**CITY OF FRANKLIN**  
**REPORT TO THE PLAN COMMISSION**

Meeting of December 7, 2017

**Unified Development Ordinance Text Amendment and Temporary Use**

Conceptual Elevations

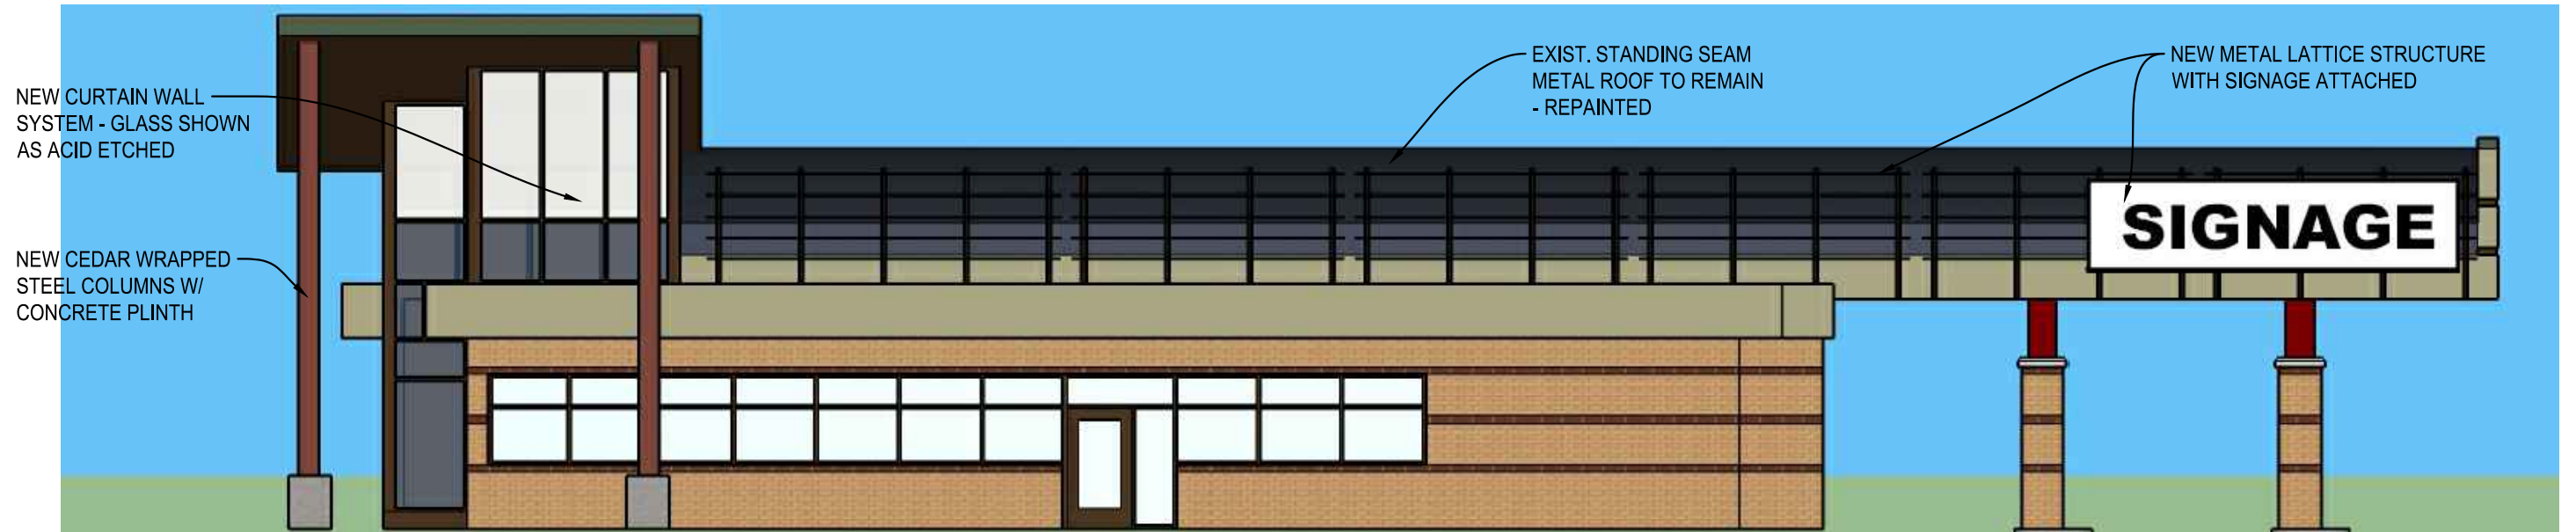
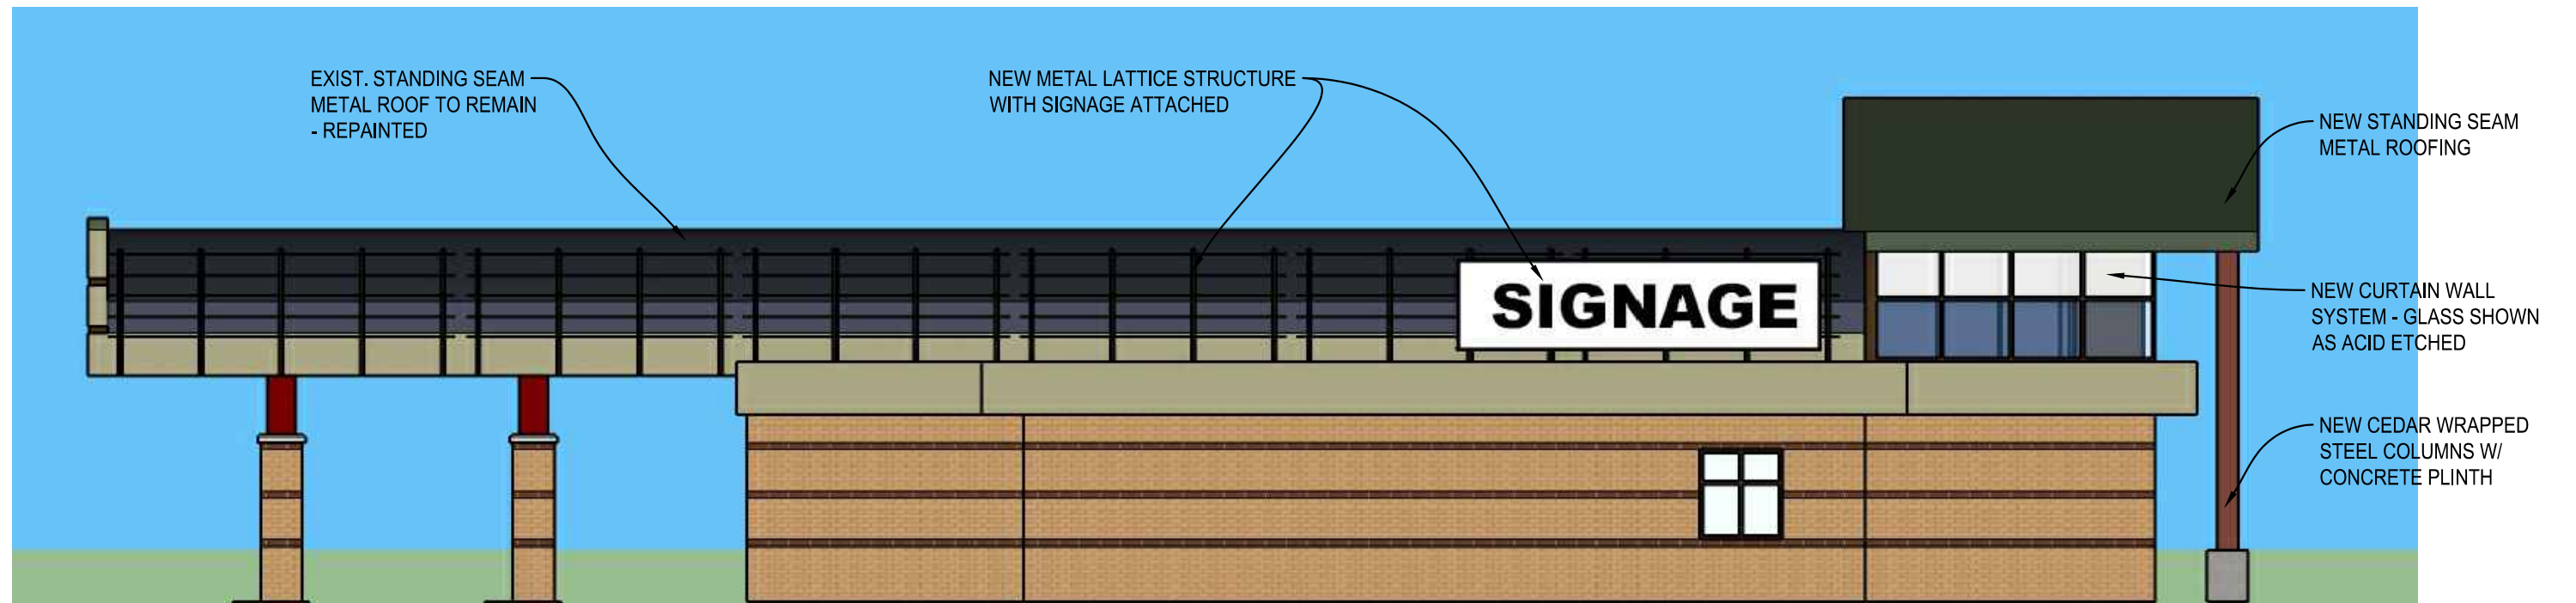
- c. Per Section 15-7.0103J. of the UDO, please verify the maximum height of the proposed building alterations. Staff recommends that detailed Building Elevations be provided depicting the height of the building, of the new entry feature, etc. – Please see attached Architectural Exterior Elevations for updates.

## CONCEPT SITE PLAN

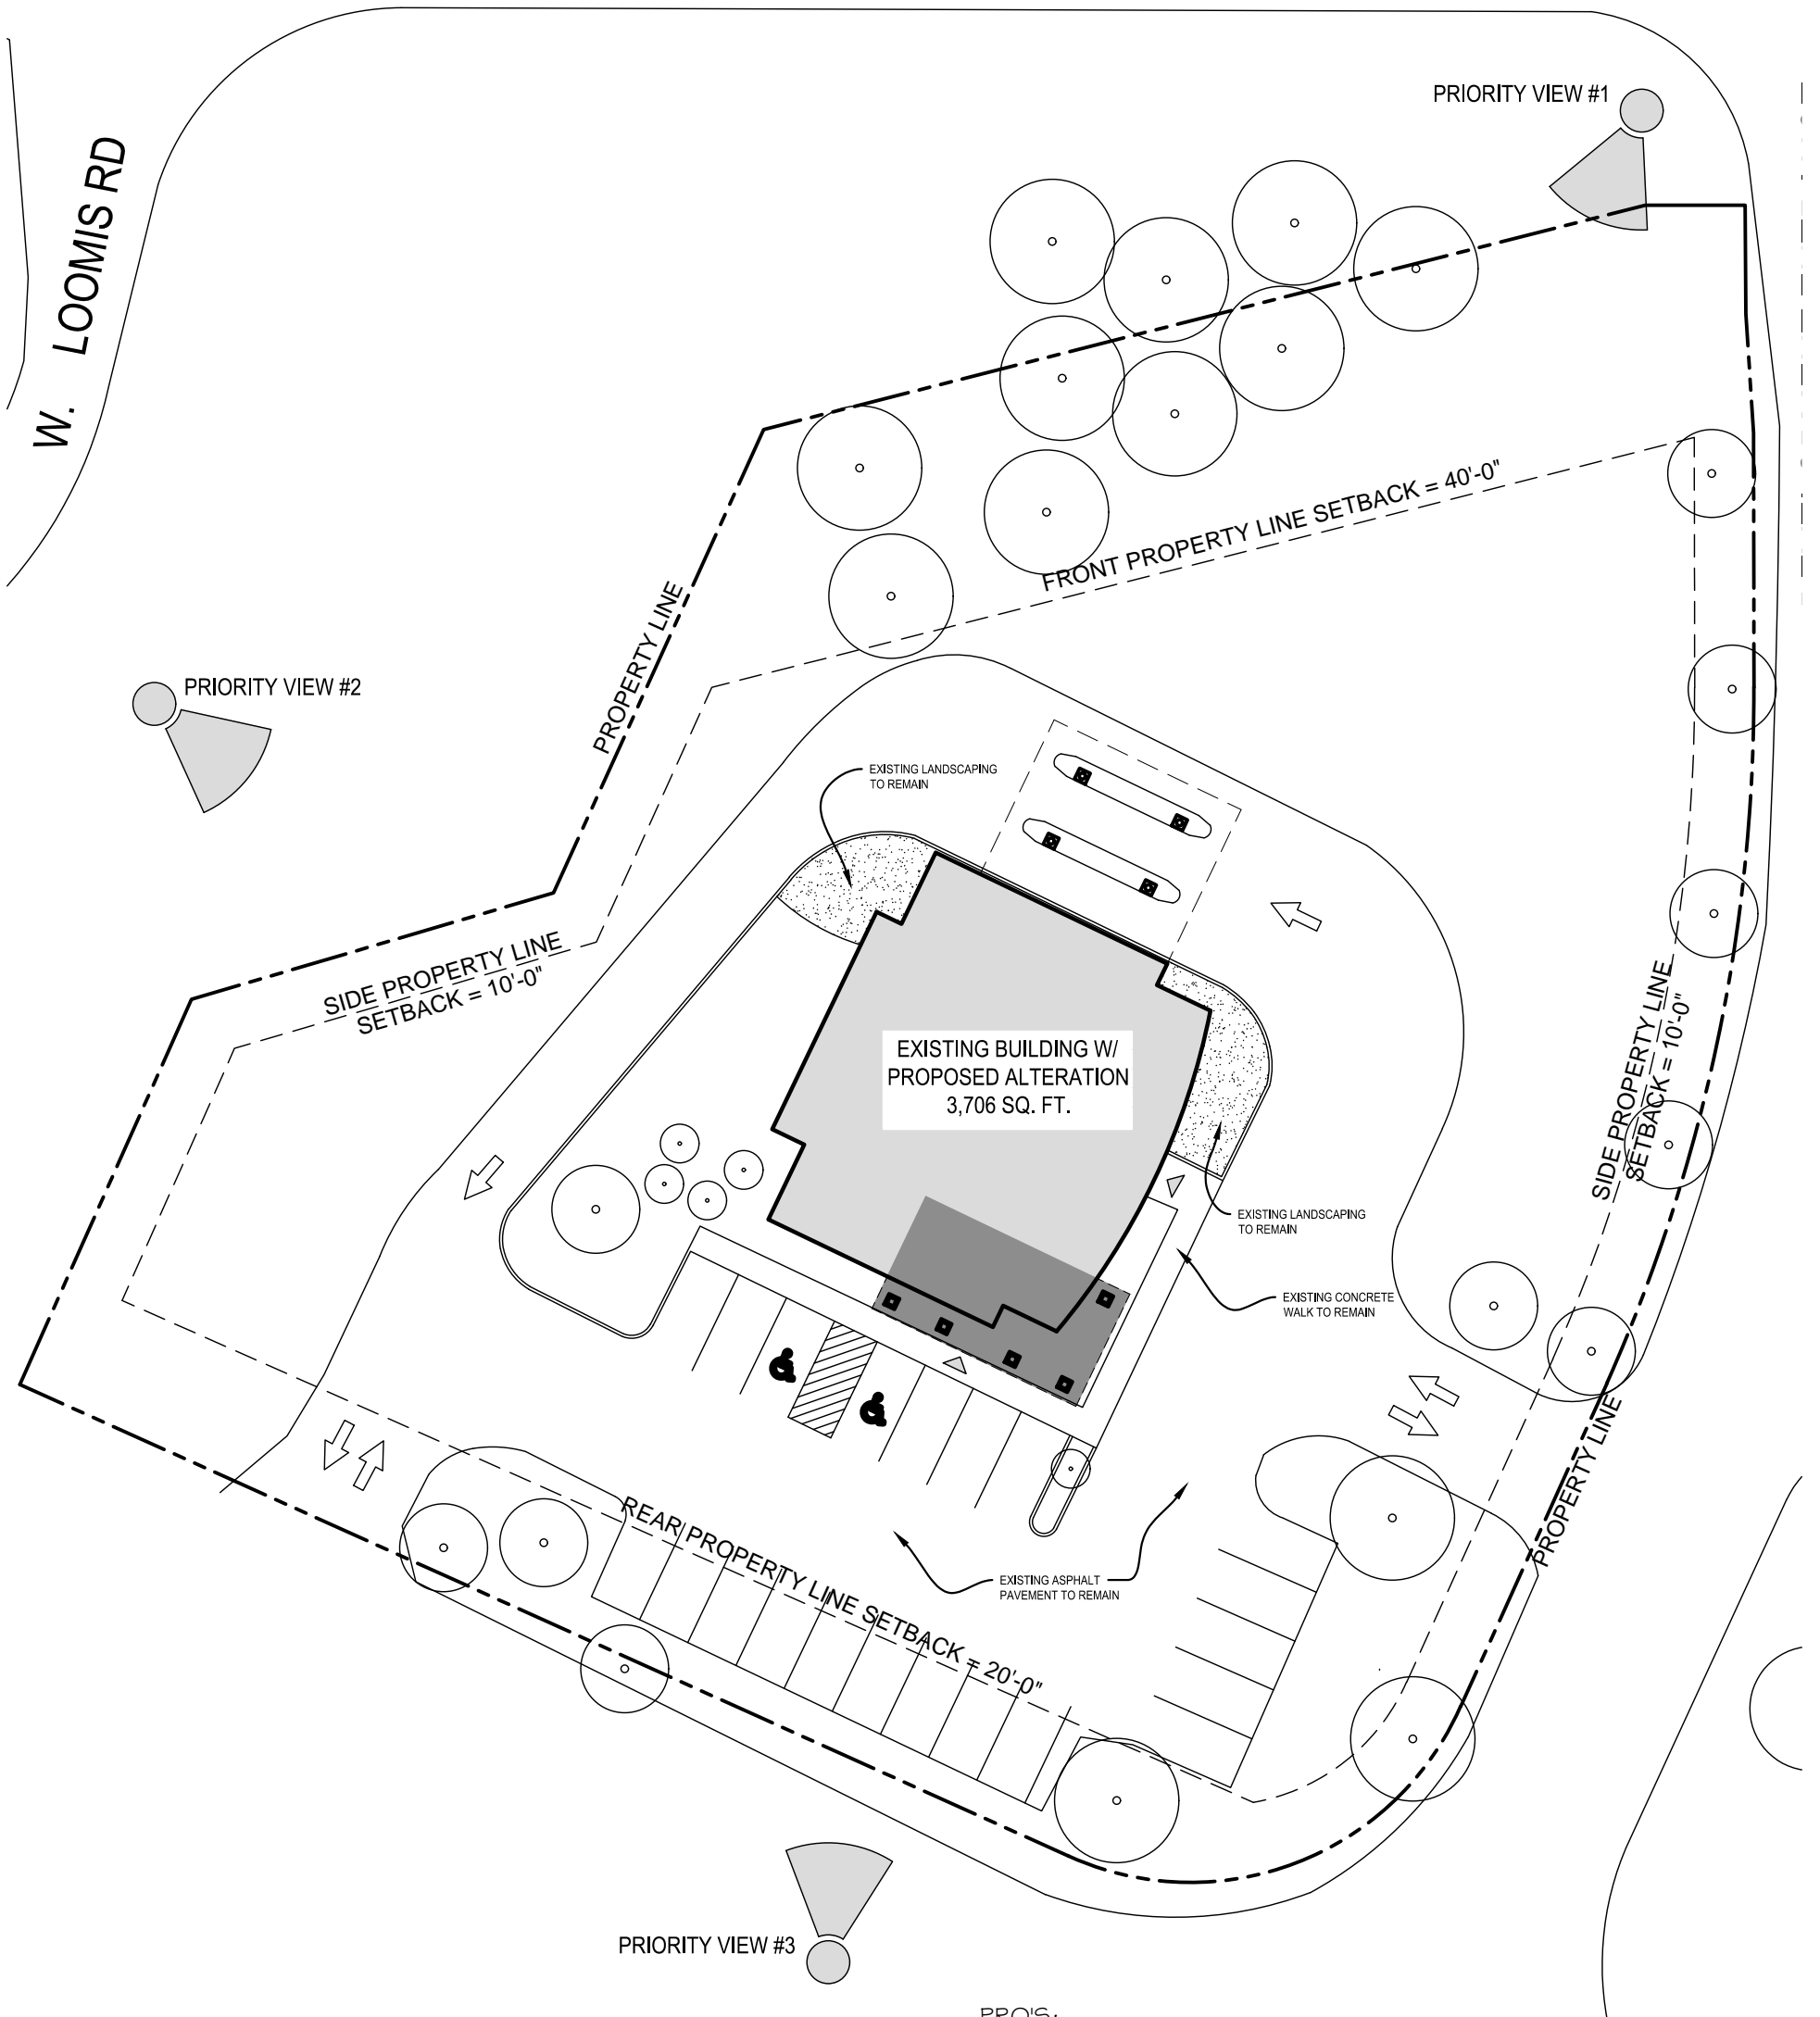
- b. Please revise the side and rear yard setbacks. Pursuant to Ordinance 2002-1735, Section 3H., the minimum setbacks are per the B-3 zoning district, which has a side yard setback of 10’ and a rear yard setback of 20’. Please note that the parking lot setback is 10’. – Please see attached Architectural Site Plan for updates.

4. Pursuant to Sections 15-7.0102C. and 15-7.0103S., please provide the Site Intensity and Capacity Calculations (please utilize the attached handout). – The client has chosen to eliminate the additional parking stalls from the project scope. Please see the attached updated Architectural Site Plan for reference.

10. Pursuant to Section 15-7.0103H., please provide additional details of the drive thru queuing lanes, and justification for the additional parking. - **The client has chosen to eliminate the additional parking stalls from the project scope. Please see the attached updated Architectural Site Plan for reference.**

15. Pursuant to Section 15-3.0803I., please identify the location of the trash dumpster, which must be screened from public view with a sight proof enclosure and landscaping, and constructed of the same materials as the principal building. - **Please see attached Architectural Site Plan and Landscaping plan for updates.**
